REGULATION No. 17
(Strength of seats)

Proposal for draft amendments to ECE/TRANS/WP.29/GRSP/2009/7

This document is a amendment to ECE/TRANS/WP.29/GRSP/2009/7 from the expert from EC and Japan. Amendments to the current proposal are indicated in bold or strikethrough characters.

Figure 10-1, amend to read:

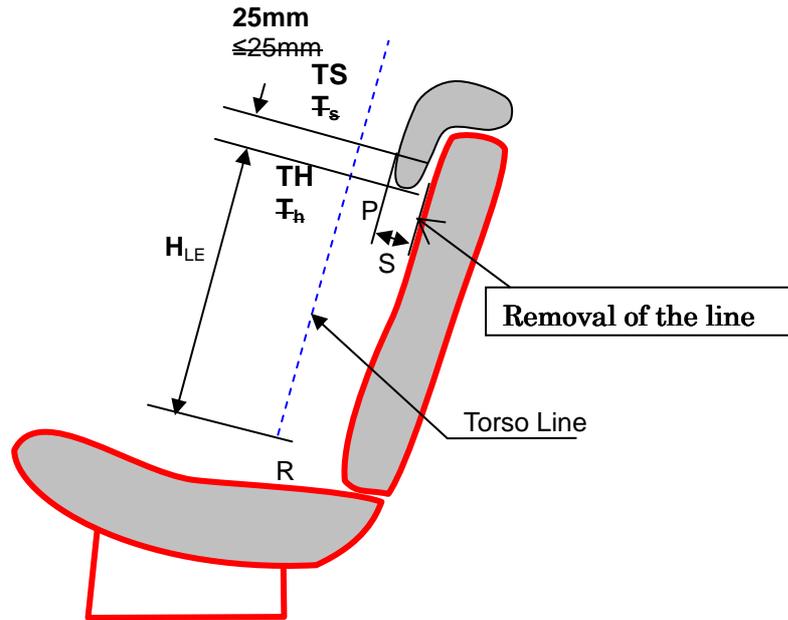
"4.2.2. ~~S is the maximum thickness of the lower edge of the head restraint (within 25 mm of the head restraint lower edge) measured perpendicular to the torso line between TH and TS- from line P.~~

S is the minimum distance between line P and seat back, in the range between 250 mm and 460 mm upward from R-point along the torso line, measured perpendicular to the torso line."

Paragraph 4.2.3., amend to read:

"4.2.3. ~~P is a line parallel to the torso line which intersects the head restraint at TS.~~

P is a line parallel to torso line and tangent to most anterior portion of head restraint, in the range from TS to TH."
